**Commonwealth Edison**  
One First National Plaza, Chicago, Illinois  
Address Reply to: Post Office Box 767  
Chicago, Illinois 60690

Subject: Dresden Station Units 2 and 3  
Response to SEP Request for  
Additional Information on Spent  
Fuel Storage Racks  
NRC Docket Nos. 50-237/249

RESPONSE TO NRC SYSTEMATIC  
EVALUATION PROGRAM BRANCH'S  
REQUEST FOR ADDITIONAL INFORMATION  
ON DRESDEN UNITS 2 AND 3 SPENT FUEL  
POOL STORAGE RACKS DATED MAY 13, 1981

Figure 1.1 Rack in Impact Configuration

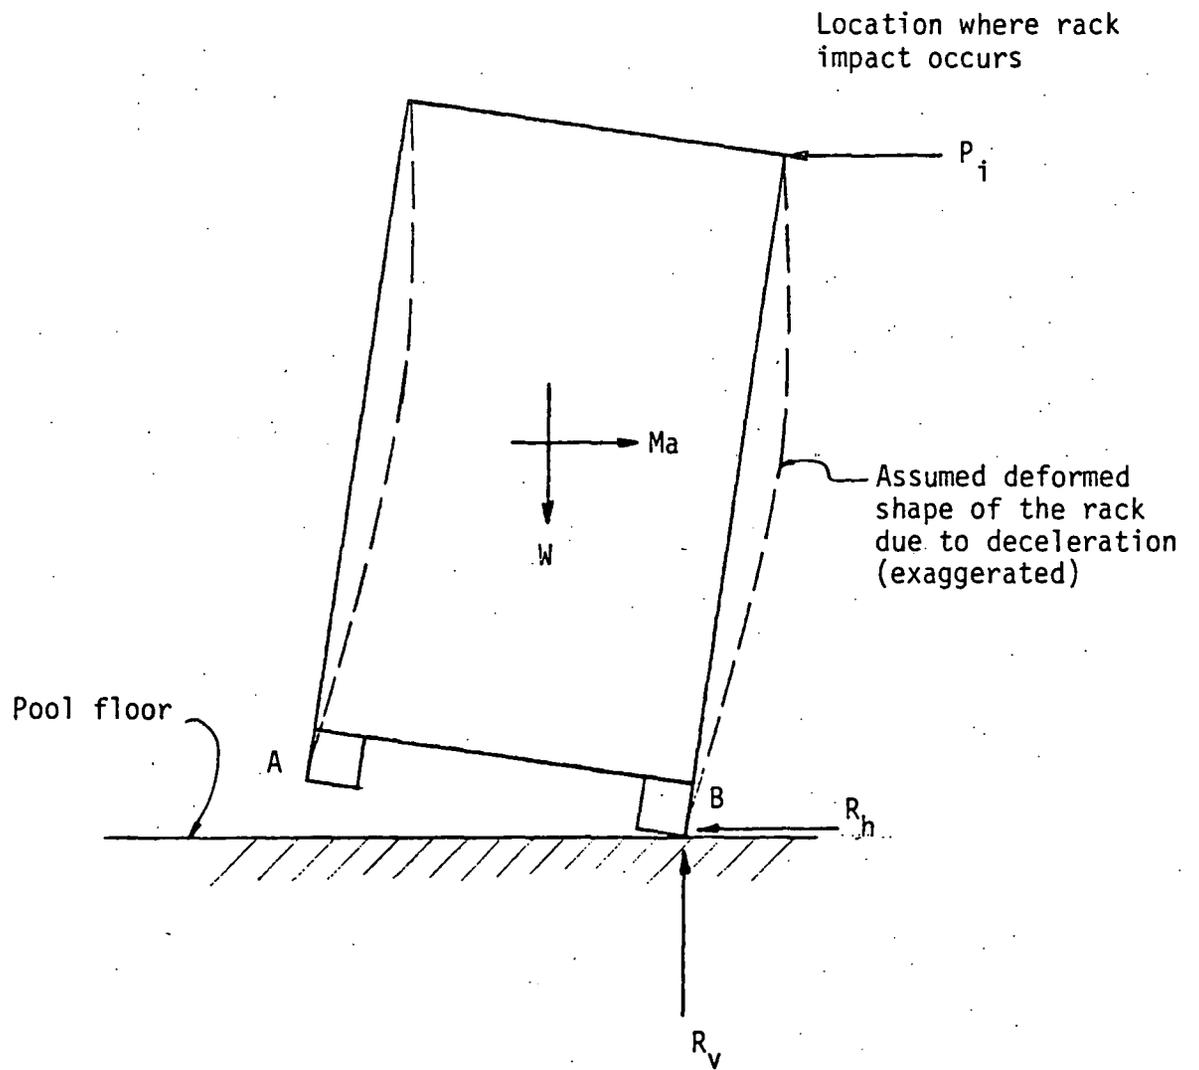
Verify that the horizontal velocity used in the rack-to-rack impact evaluation was that from the nonlinear analysis of the empty rack with the 0.2 coefficient of friction between the rack legs and pool floor. Revise Table 3.4-2 to reflect any increases in stresses in the overall rack structure under such a condition, as appropriate. Clearly state and justify all assumptions made in your analysis.

The rack-to-rack and rack-to-pool wall impact during rocking would occur at the top edge of the racks (see Figure 1.1). Using an energy-balance method, and assuming elasto-plastic behavior of the tube walls, analysis of rack-to-rack and rack-to-pool wall impact was performed for a fully loaded 9 x 13 rack (which is the most critical) with an impact velocity of 13.0 in/sec. The maximum impact force ( $P_i$ ) developed at the top edge of the rack during the impact was equal to 48.51 kips, and the maximum deceleration ( $a$ ) of the rack was 0.4g. These values were obtained assuming that during the impacts, the change of the impact force and the deceleration were linear, and the rack would completely stop at the end of the impact (no rebound was assumed, hence conservative).

The reaction forces ( $R_v$ ,  $R_h$ ) induced at rack legs (shown in Figure 1.1) would vary with the actual coefficient of friction between the rack legs and pool floor. Using a friction coefficient of 0.75, these reaction forces were computed as shown in Table 1-1. As reported in the licensing report,

NSC-COM-0219-R001, the stresses for various rack components given in Table 3.4-2 were obtained from analysis assuming that the rack cannot rock or slide. Based on this analysis, it was found that the elements which had the highest stresses were located at the lower part of the rack near the legs. The reaction forces at the rack legs obtained from this analysis are also listed in Table 1-1. A comparison of these two sets of values in Table 1-1 reveals that the reaction forces obtained by ignoring rocking and sliding are much higher than those if the rack is assumed a tilted position during rocking. Therefore, the maximum stresses at the critical lower part of the rack during rocking must also be less than the stress values given in Table 3.4-2. However, due to deceleration of the rack during the impact, the rack would also deform in a bending mode (shown as dotted line in Figure 1.1) which would cause additional maximum stress of 0.9 ksi in the tube wall and filler plate at mid-height of the rack. But, this additional stress is too small to be significant.

On the basis of preceding analysis, it is concluded that stresses in the overall rack structure under rack-to-rack and rack-to-pool wall impact conditions are not as critical as the stresses shown in Table 3.4-2 with the exception of tube walls near the top edge of the rack, where localized plastic deformation may be expected due to impact.

Figure 2.1 Rack in Rocking Position

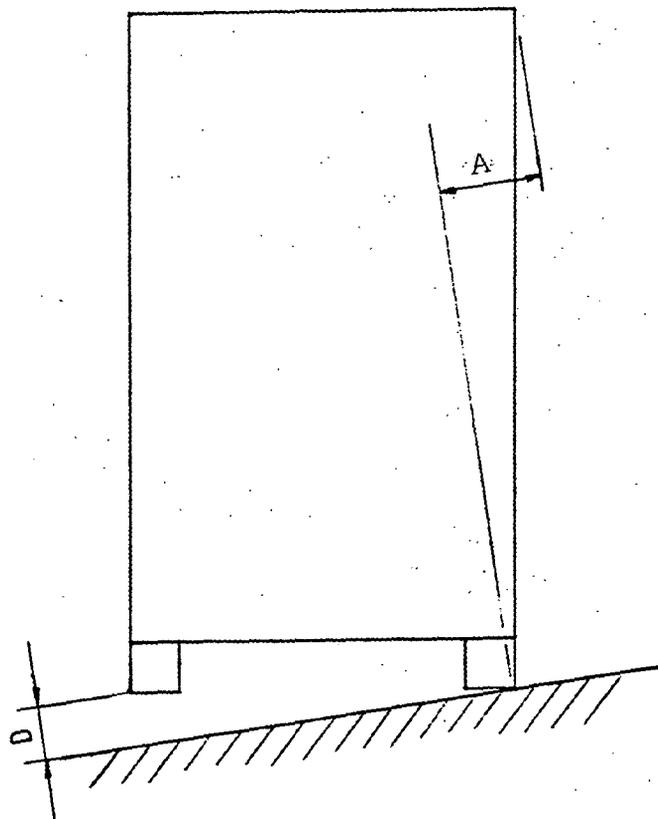
Provide the results of your analyses to demonstrate that the 4.625-inch minimum gap between the racks and pool wall is adequate (provides for the minimum factors of safety against impact stated in Standard Review Plan Section 3.8.5) considering both rocking and sliding of the racks under all postulated rack loading conditions and considering the variations in the coefficient of friction between the rack feet and pool floor. If such impact cannot be precluded, demonstrate that the local and gross effects on the racks and pool wall are acceptable. Revise Tables 3.4-2 and 3.5-2 to reflect any increase in loads and stresses as appropriate. Clearly state and justify all assumptions made in your analyses.

From the nonlinear analysis of an empty 9x13 rack (considering both rocking and sliding effect and assuming 0.2 coefficient of friction between the rack legs and pool floor) for a SSE motion in the short direction of the rack, the maximum lift-off at one side of the rack and relative horizontal displacement at top of the rack due to rocking (shown as D and A in Figure 2.1) were 0.56 in. and 2.01 in., respectively (See Table 2-1); the sliding distance of the rack was 1.012 in. (Refer to page 3-38, Licensing report NSC-COM-0219-R001). Thus, the total displacement at the top of the rack was computed to be 3.022 in. Hence, the factor of safety against the empty rack impacting the pool wall is  $(4.625 \div 3.022 =) 1.53$ . Energy-balance method was then used to compute D and A values of the rack due to rocking for various assumed loading conditions. In this approach, vertical displacement of the center of gravity (cg) of the rack was determined by equating the kinetic energy of the rack to the work required for raising the cg of the rack. The results obtained are summarized in Table 2-1. Study of the values given in Table 2-1 showed that: (a) Energy-balance method gave very conservative results when compared with results from nonlinear analysis. Thus, the factor of conservatism when energy-balance method is used may be estimated as  $(6.96 \div 2.01 =) 3.46$ , (b) If this factor of conservatism is taken out for the partially loaded cases, the maximum value of A would be 2.26 inches only.

Thus, the maximum total displacement at the top of the rack would be equal to  $(2.26 + 1.01 =) 3.27$  inches. Therefore, it can be concluded that the minimum factor of safety against impact (1.1) as stated in Standard Review Plan Section 3.8.5 for SSE motion is met and impact of racks on pool walls is not anticipated. However, to demonstrate that additional margin exists, the pool walls were evaluated assuming that impact of racks may occur. The method of analysis used and assumptions made are presented in the following paragraph.

Figure 3.1 Force-Displacement Function for Pool Slab

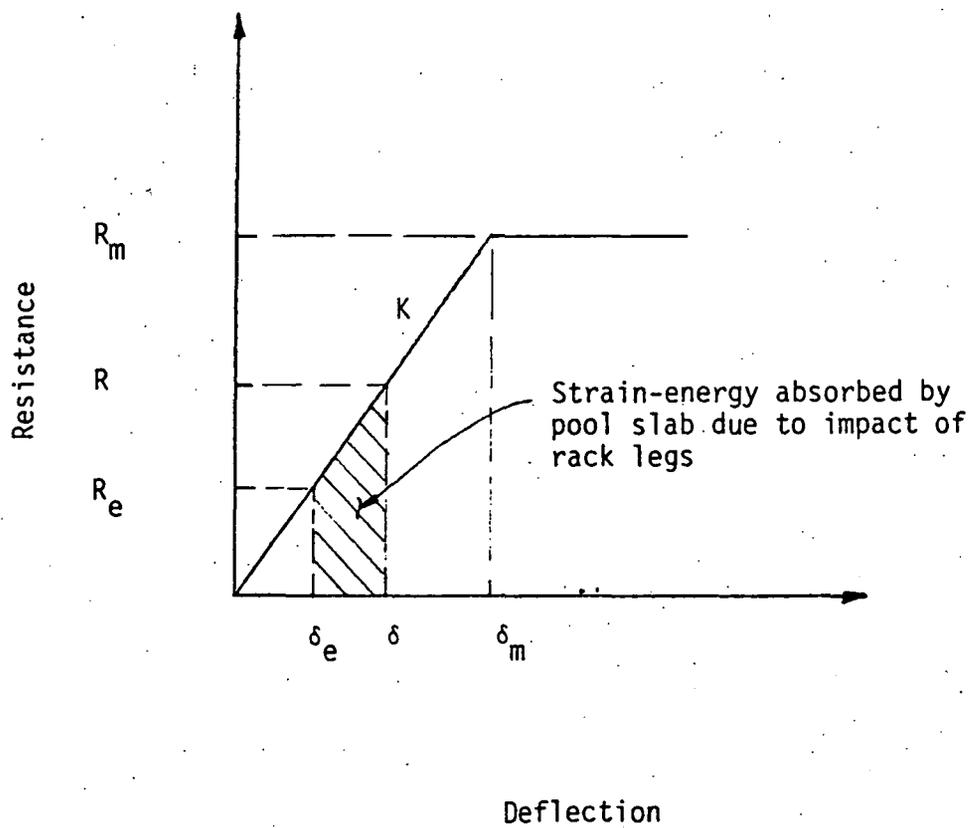
Considering both rocking and sliding of the racks under all postulated rack loading conditions and considering the variations in the coefficient of friction between the rack feet and pool floor, provide the results of your analyses to demonstrate that the local and gross effects of the uplift and resulting impact of the rack legs with the pool floor are acceptable for both the rack and pool slab structures. Revise Tables 3.4-2 and 3.5-2 to reflect any increase in loads and stresses, as appropriate. Clearly state and justify all assumptions made in your analyses.

For the purpose of analyzing the pool slab subject to impact of rack legs, the pool slab was idealized as a single degree-of-freedom system with force-displacement characteristics as shown in Figure 3.1. The parameters related to this force-displacement characteristic were then determined for the pool slab and the following values were obtained:

- (a) Maximum resistance ( $R_m$ ), computed on the basis of ultimate moment capacity of the pool slab, was equal to 30016.8 kips.
- (b) Elastic spring constant ( $k$ ) was 382100 kips/in. The effect of concrete cracks was also taken into consideration.
- (c) Total existing uniform load ( $R_e$ ) acting on the pool slab was 8334.5 kips. Weights of water, slab, loaded racks and loads resulting from SSE are all included.
- (d) Corresponding displacements of the pool slab were 0.0786 in. for  $\delta_m$  and 0.0218 in. for  $\delta_e$ .

Using energy-balance method (i.e. total strain-energy absorbed by the pool slab minus the strain-energy due to existing loads equals the input kinetic energy resulting from impact of rack legs), the final deflection ( $\delta$ ) and applied load ( $R$ ) on the pool slab were obtained. These values were 12707 kips (for  $R$ ) and 0.0333 in. (for  $\delta$ ), respectively. The shear capacity of the pool slab was investigated to determine the margin of safety against shear failure. Based on the ultimate shear capacity due to diagonal tension at a distance equal to effective depth of pool slab, the ultimate load capacity for the pool slab was computed to be 17643 kips. Therefore, the pool slab remained within the elastic range and was safe from shear failure while subjected to impact of rack legs.

Figure 4.1 Showing Location of CG of 9x13 Rack

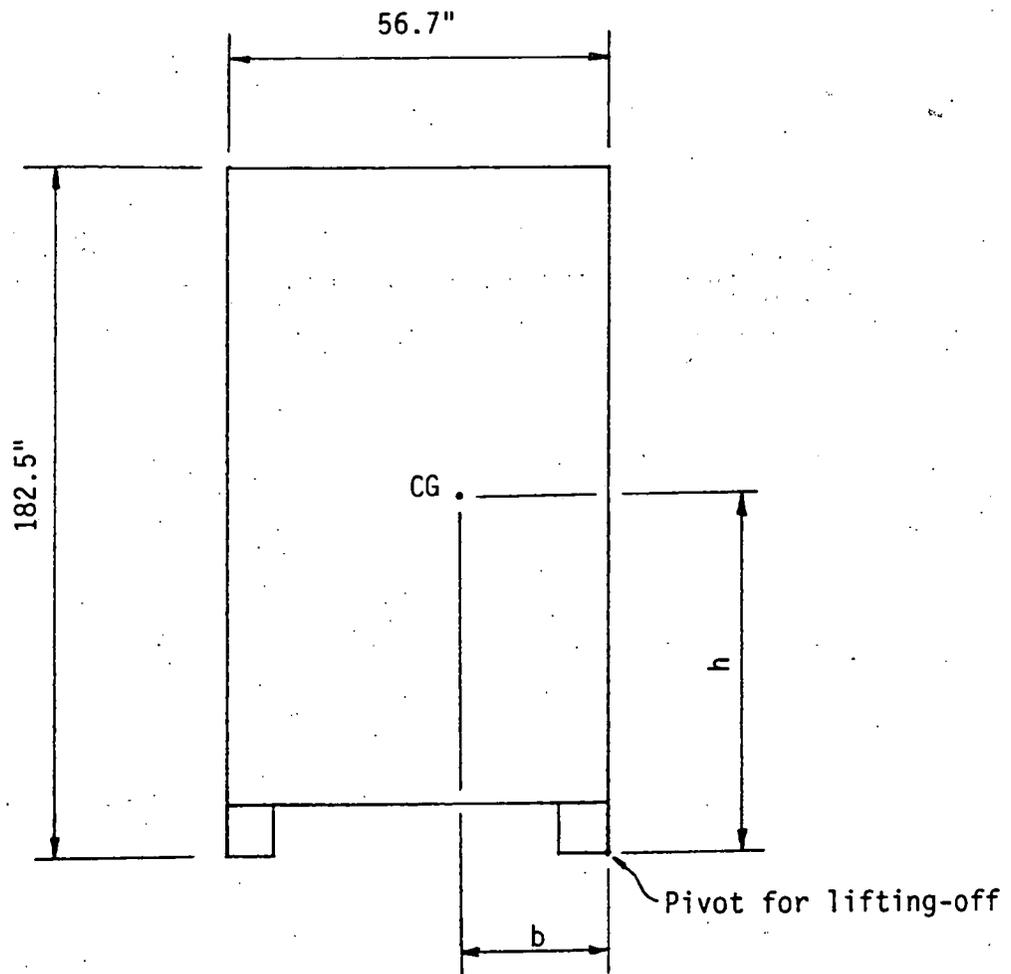
For all loading conditions considered in the above analyses, provide the location of the center of gravity assumed.

The location of the center of gravity (cg) of racks for various loaded condition considered in the preceding analyses are as follows (see Figure 4.1 for symbols):

- (a) For empty rack and fully loaded rack, b is 28.35 inches and h is 97.13 inches.
- (b) For rack loaded with one row of tube cells on pivoted side of the rack, b is 18.1 inches and h is 97.13 inches.
- (c) For rack loaded with two rows of tube cells on pivoted side of the rack, b is 15.58 inches and h is 97.13 inches.
- (d) For rack loaded with three rows of tube cells on pivoted side of the rack, b is 15.62 inches and h is 97.13 inches.
- (e) For rack loaded with four rows of tube cells on pivoted side of the rack, b is 16.8 inches and h is 97.13 inches.
